City of Portland, Maine - Building or Use Permit Application
 389 Congress Street, 04101 Tel: (207) 874-8703, Fax: (207) 874-8716

Proposed Project Description:
 Amend Permit #01-0367 for New 37' X 42' Single Family Home (Foundation Only)

**CITY OF PORTLAND, ME
BOCA 1999 Plan Review Record
One and Two Family Dwelling**

BUILDING PERMIT REPORT

REAR ELEVATION
 1/8" = 1'-0"

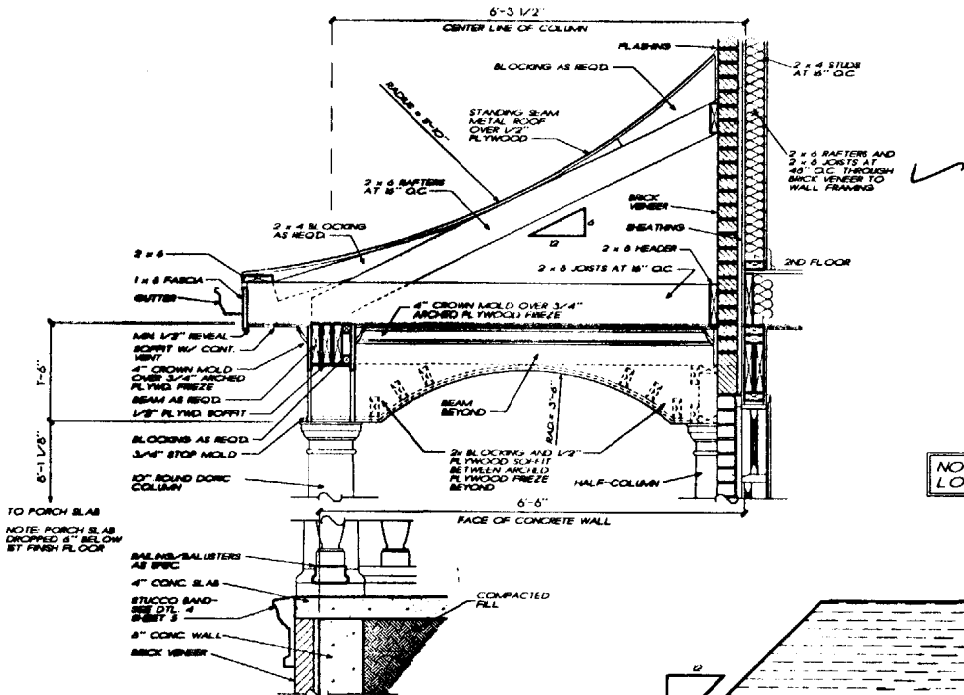
NOTE: ATTIC VENTILATION PER LOCAL CODES AND REQUIREMENTS
 Sec. 1210.4

ROOF PLAN
 1/8" = 1'-0"

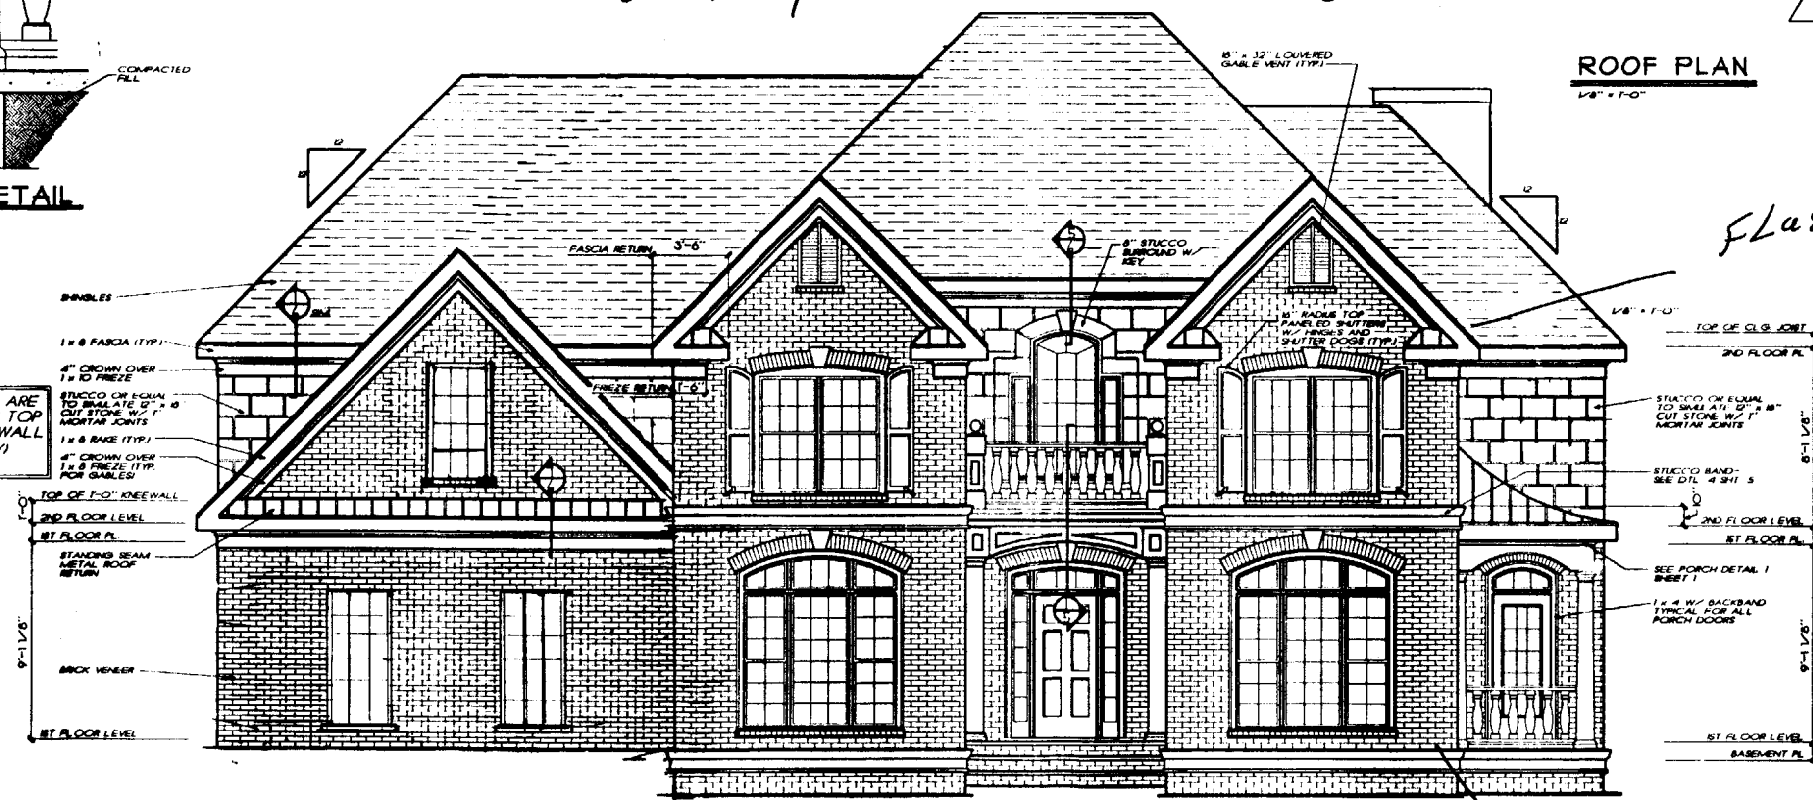
Roof 1:27
 Ch. 157

Flashing Sec. 1406.3.1

FIRST FLOOR PLAN

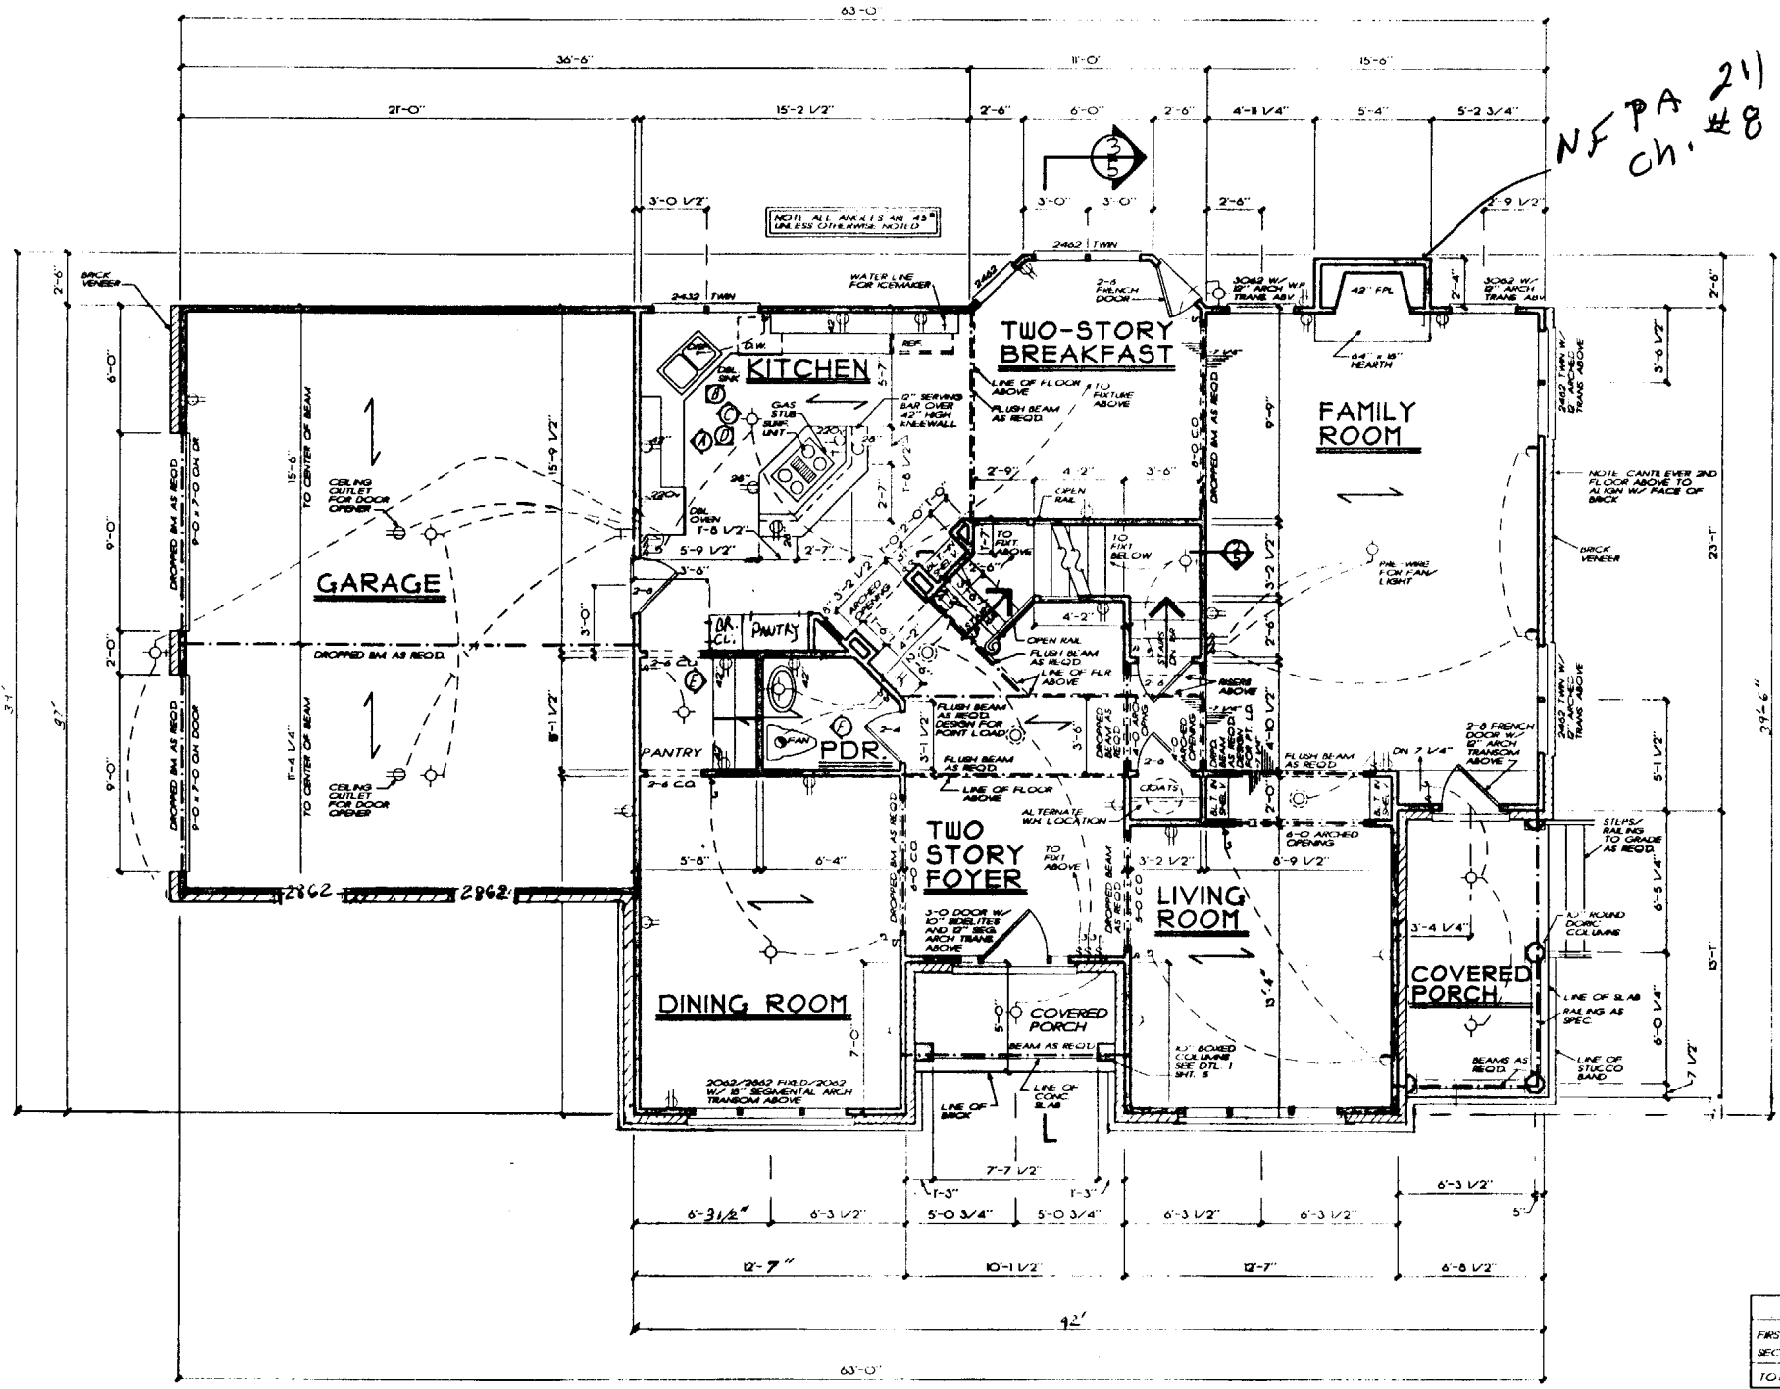
NFPA 211
CH. #8

SECOND FLOOR PLAN

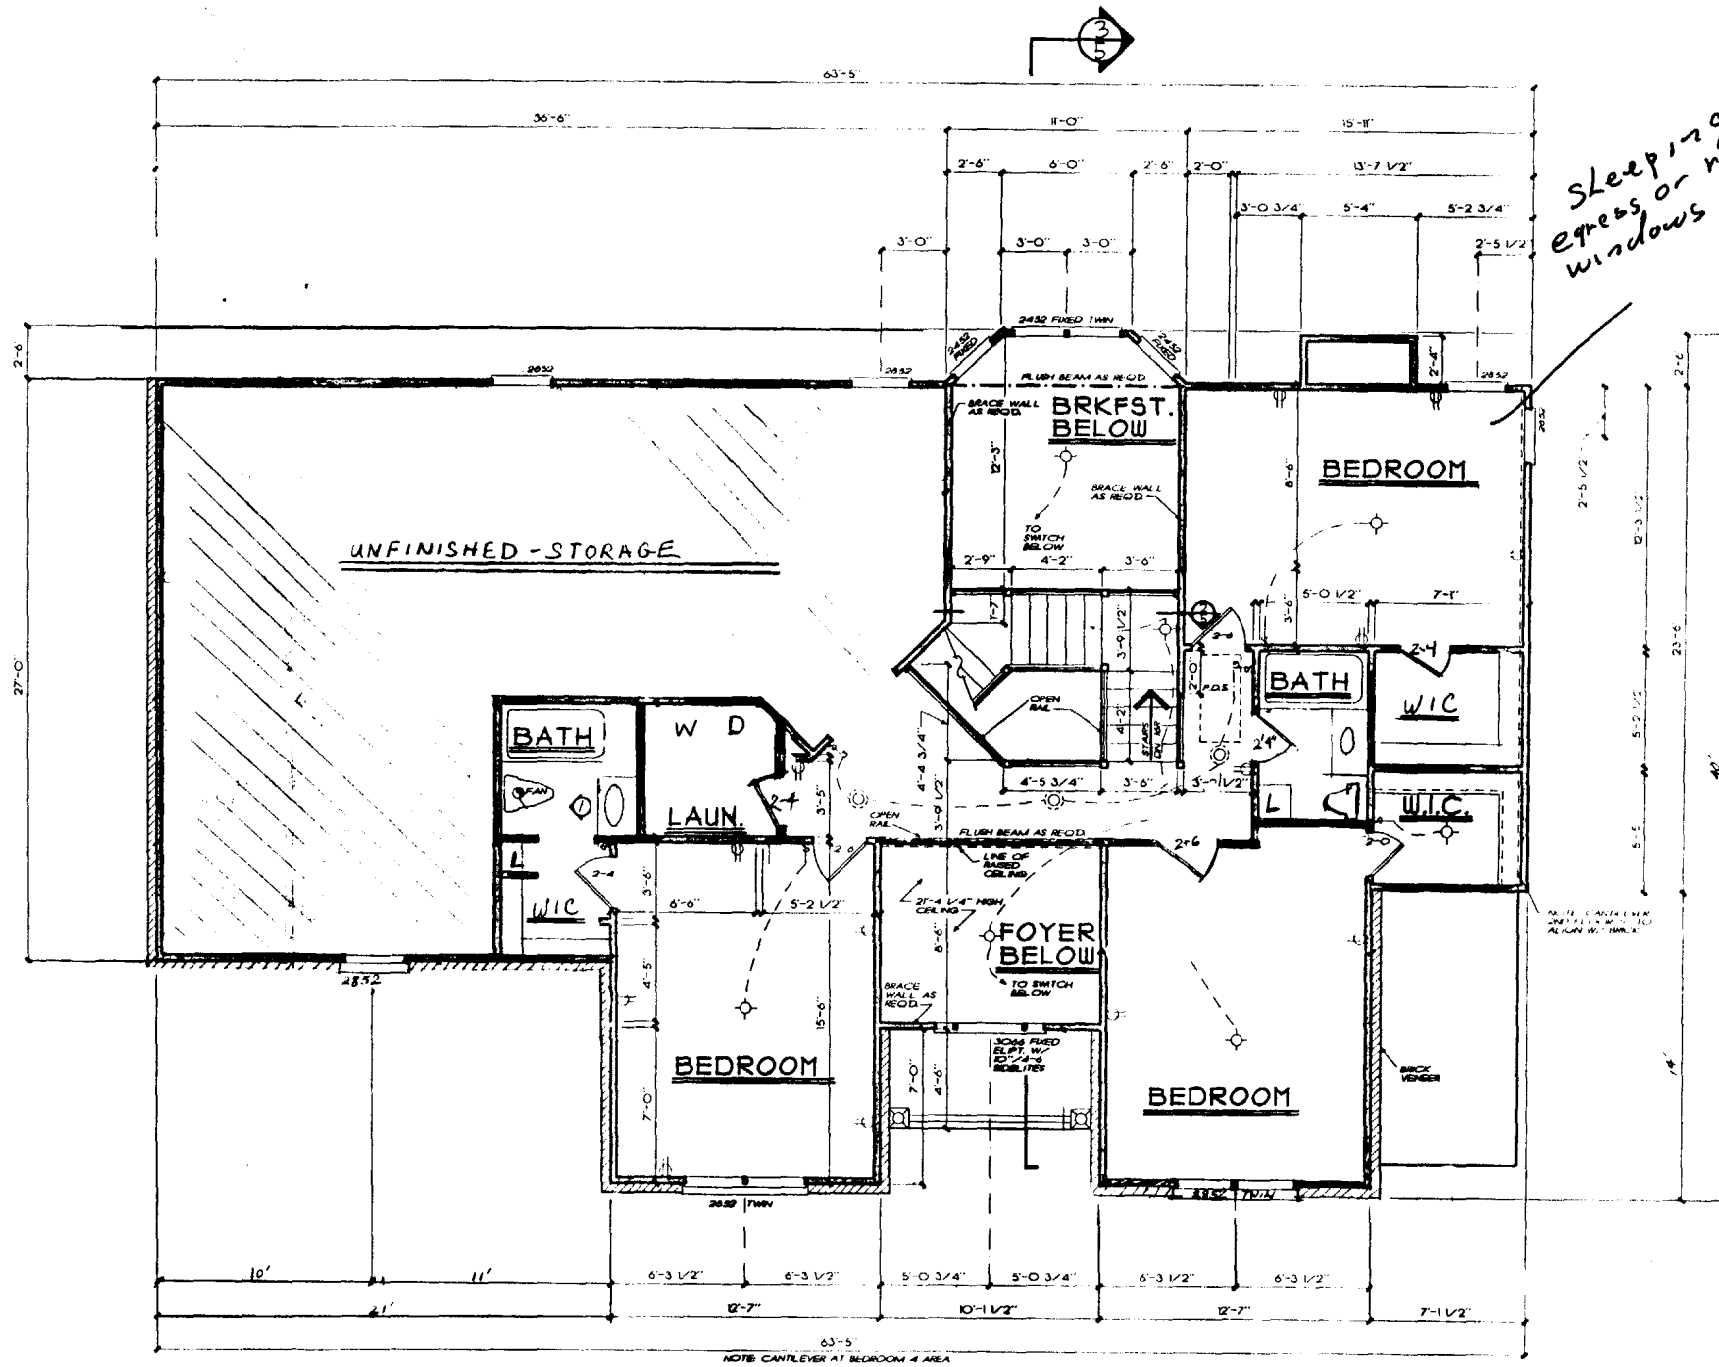
Sleeping roof egress or rescue windows Sec. 1916.4
